Appendix C.4
Public Comments (P/PH)
P650-P751

Comments on the Los Angeles Aerial Rapid Transit Project Draft EIR

Figure 3: Area of Potential Impact (API). Base image courtesy of Google Maps.

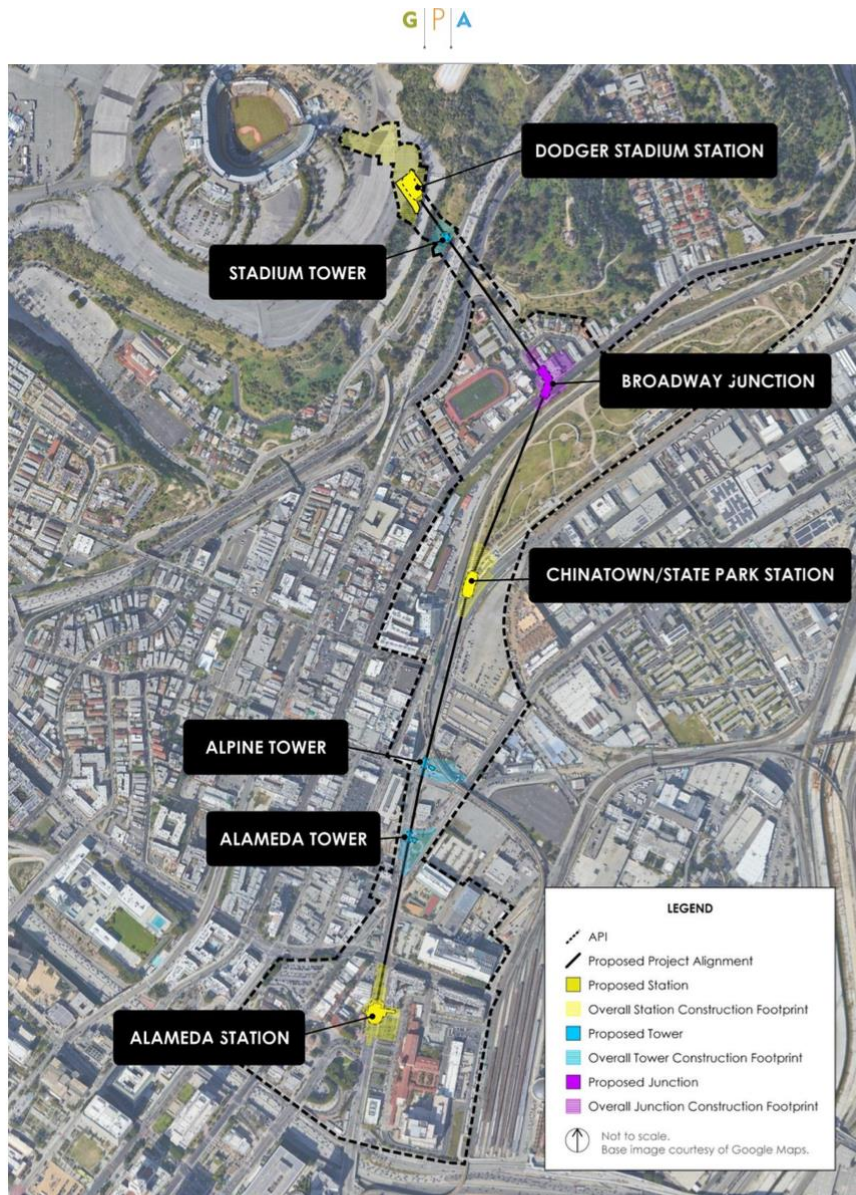
P701-4

P701-5

Landslide Area Near the Broadway Junction (NavigateLA)

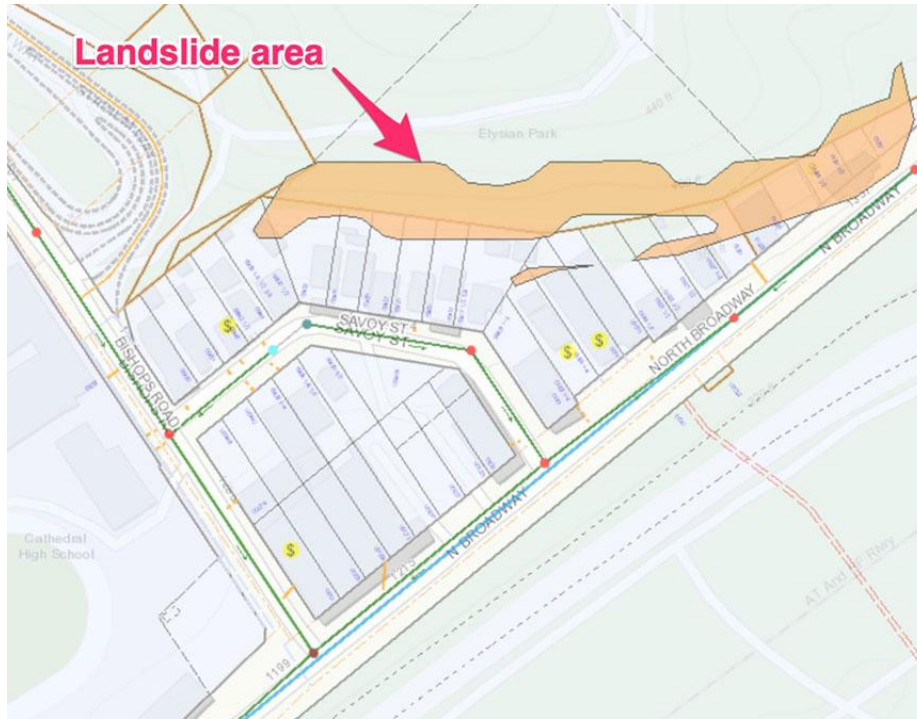
- Even with mitigation, the construction noise at NSR-17S is estimated at 80 to 90dB without mitigation and approximately 70-80dB with mitigation. This is outrageous.
- The vibration caused during construction of the Broadway Junction's foundation may cause damage to our homes. There are also retaining walls in our 100+ year old hillside neighborhood that were built prior to current building codes that may be damaged and cause instability to our hillsides. Most of the properties on the west and north side of Savoy Street are in a landslide area. We are concerned that the Radio Hill hillside could become unstable during construction of the Junction and trigger a landslide.

P702-30

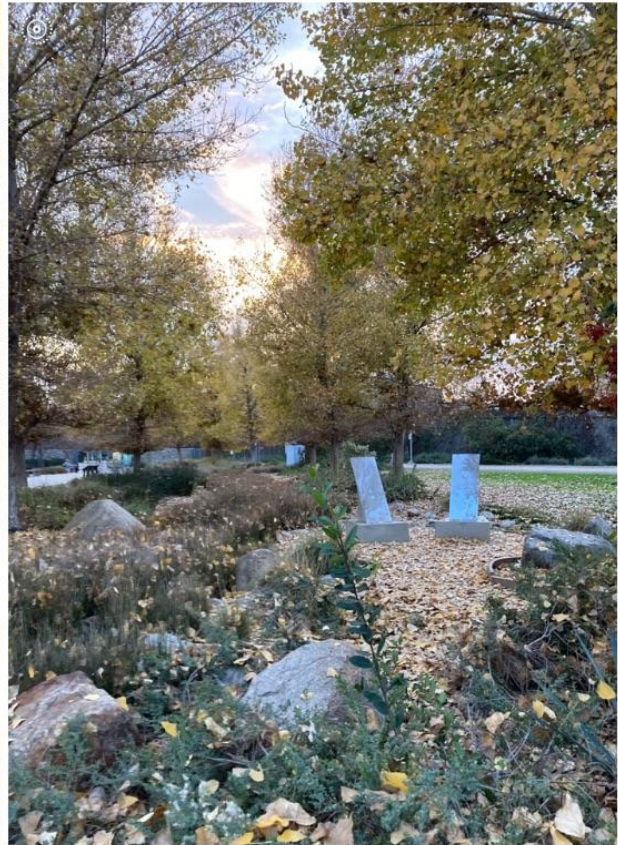
- Also figures 5-14, 5-20b, 5-21, 5-22, 5-24 are taken from deceptively far away from the subject, to make the towers or stations look small.
- There is a significant visual impact of the gondola station at the entrance of LA State Historic Park and the gondola cabins as they travel in and out of that station over the park, which is not shown or discussed in the visual impact assessment. The DEIR should show a rendering of this site. This site is the end of the stream (or river) that runs along the eastern edge of the park. This stream fills up and flows during heavy rains. There is also an art installation/monument at this site, called “Origins” by Debra Scacco. This is just north from where LA ART is proposing to build restrooms and concessions.

Close Up of DEIR Image Showing the Base of the Alpine Tower

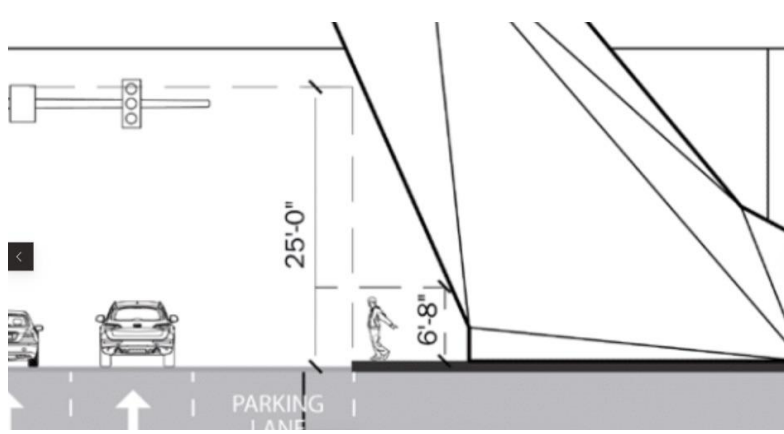
- Alpine Tower requires that a traffic lane on Alameda Street be sacrificed in order to maintain a sidewalk around the base of the 200 ft tall gondola tower, which sits at the edge of the existing curb/sidewalk. The tower, however, still crowds the sidewalk by leaning into the airspace above the sidewalk. This looks like a very unpleasant pedestrian experience. The sidewalk needs to be wider, but this project is already taking space on our streets that could be used for wider sidewalks, bus lanes, and bike lanes. What is the impact of this tower, the space it needs on the street, to planned improvements to Alameda Street? Does this mean a protected bicycle lane or a bus lane can never be on this side of Alameda Street?

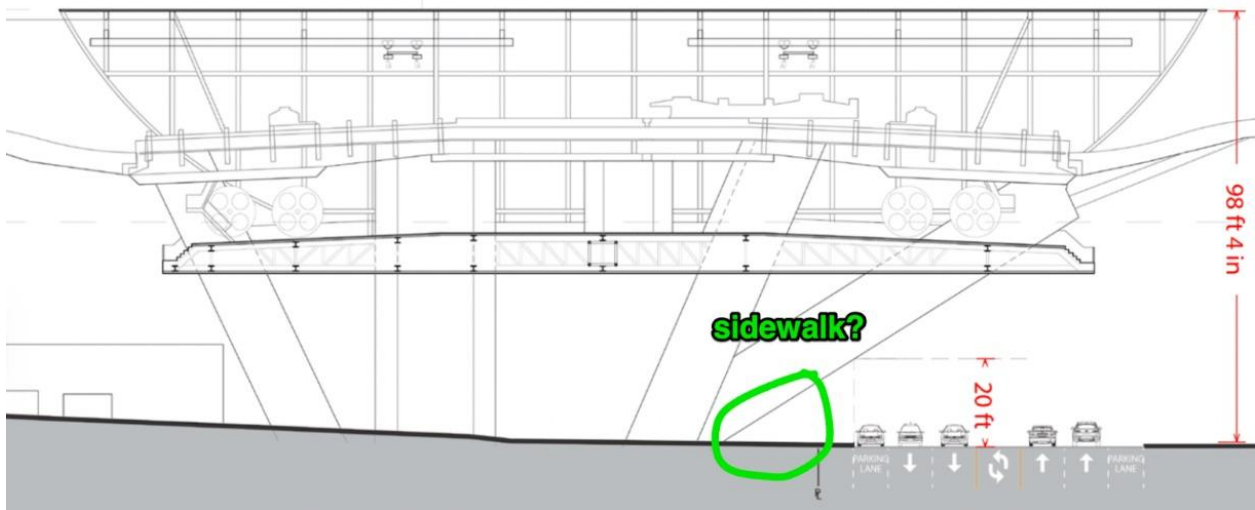
- **Broadway Junction:** More information is needed on the sidewalks around the Broadway Junction, especially at the area indicated in the image below. How high is the overhead clearance of the support column, how wide is the usable space of the sidewalk? There is a bus stop located at this location on Broadway. Will this interfere with a bus stop shelter? How wide will the sidewalk be along Bishop's Road? Currently, there is no sidewalk, even though it is an official route to Dodger Stadium.

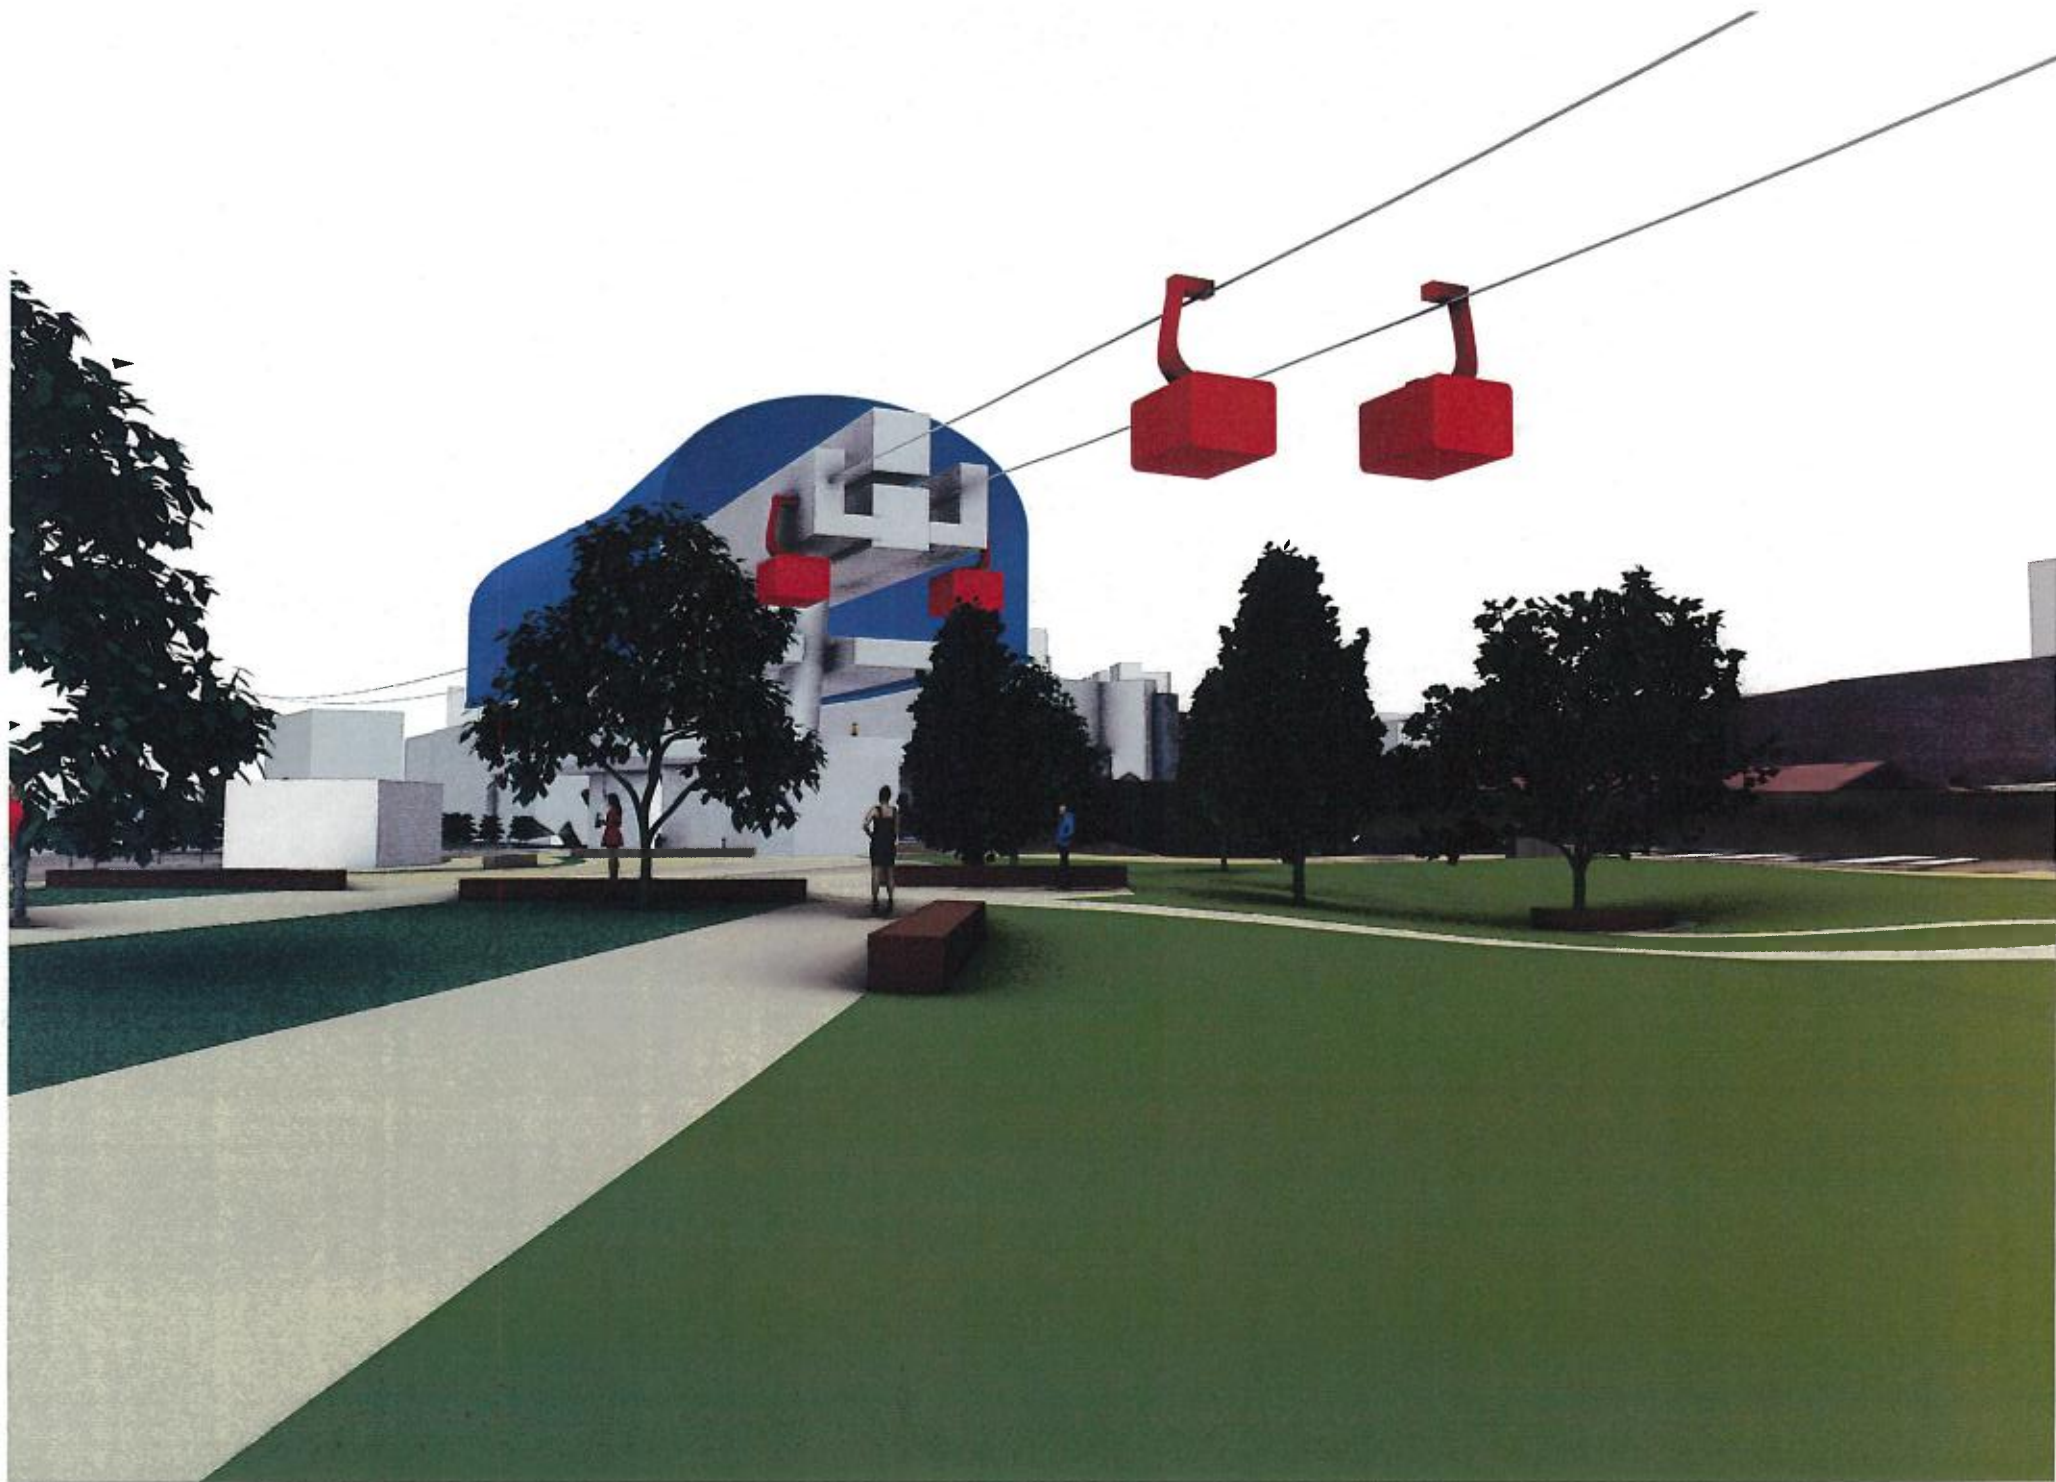
- h. The DEIR has concluded that there are no significant view impacts as a result of the aerial tram. I have attached few screen shots of a 3D model that represents the Aerial tram, and the China town station as seen from the park. For a park that is designed to have open skies, such conclusion appears to be absurd. The fact that the study did not provide a 3D digital tool for the public to be its own judge on the view impact may explain why the proponent selectively picked a few convenient spots to render (out of a 3 D model that clearly was not make available for public viewing.

P703-12

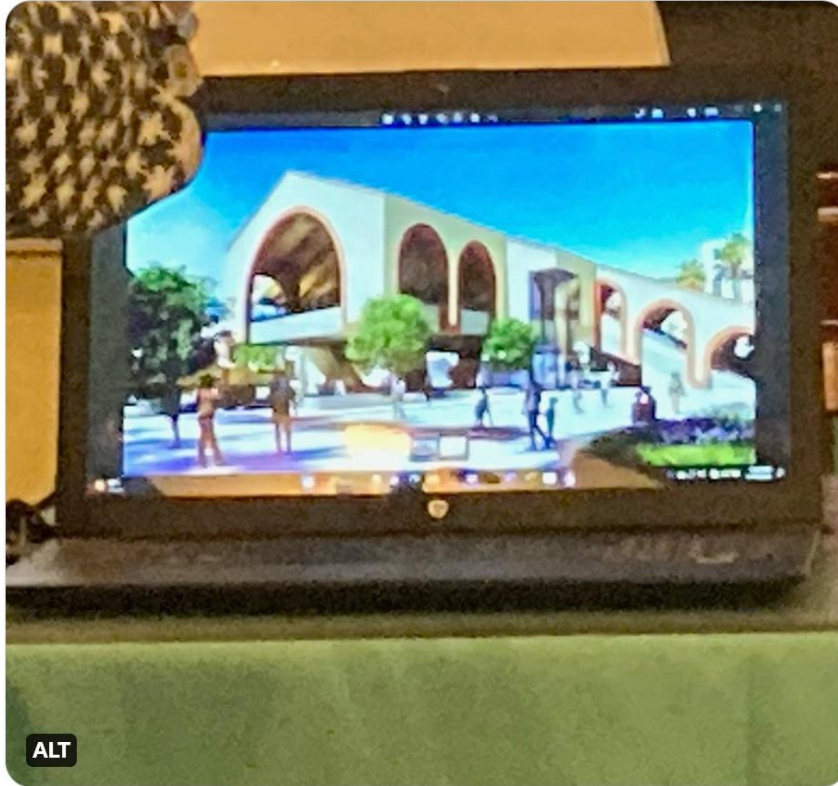
Gondola station and designs should not be cookie cutter or generic. This would be built at the birthplace of our city. LA ART claims this will be iconic, but how is the design iconic? There is no sense of place. Stations look generic and towers are a stark gray concrete. We don't need more gray concrete in our historic neighborhoods. The cabins also appear to be standard cabins.
